**OHIO TURNPIKE AND
INFRASTRUCTURE COMMISSION**

ADDENDUM NO. 1

**PROJECT NO. 56-16-04
ELMORE MAINTENANCE BUILDING HVAC ROOFTOP REPLACEMENT
MILEPOST 79.9, EASTBOUND
OTTAWA COUNTY, OHIO**

↑ ARCHITECTURAL REFLECTED CEILING PLAN
SCALE: 1/8" = 1'-0"

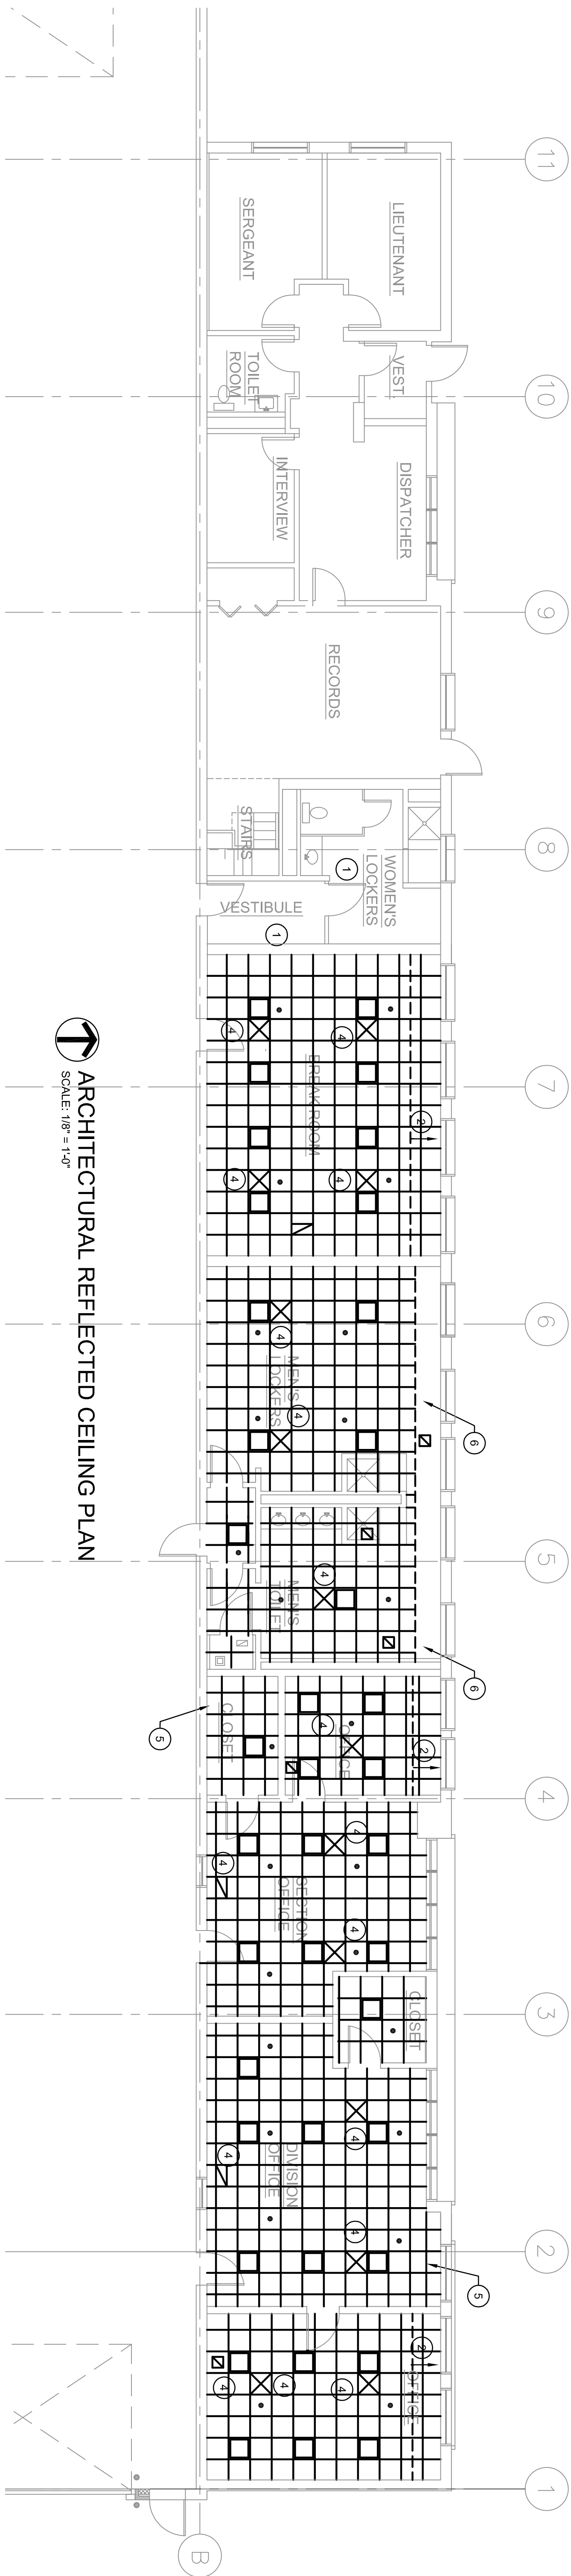
Q#1 Regarding existing drywall ceilings in men's locker room and restroom. There are no notes about how to handle them. Please clarify the scope relating to demolition.

Modification to Plan Sheet 2 of 8

Plan Sheet 2 of 8 is replaced and superseded with the attached Plan Sheet 2 of 8 revised via this Addendum No. 1 as described in the response to Q#1 and incorporated by reference into the Contract Documents.

A#1 The Contractor is required to perform the demolition of existing drywall. Accordingly, a new General Note No. 8 is added through this Addendum No. 1 to Plan Sheet 2 of 8 to read as follows:

"8. DEMOLITION OF EXISTING DRYWALL CEILING IN THE MENS TOILET AND LOCKER ROOM SHALL BE PERFORMED BY THE CONTRACTOR."

8. DEMOLITION OF EXISTING DRYWALL CEILING IN MENS TOILET AND LOCKER ROOM SHALL BE PERFORMED BY THE CONTRACTOR.
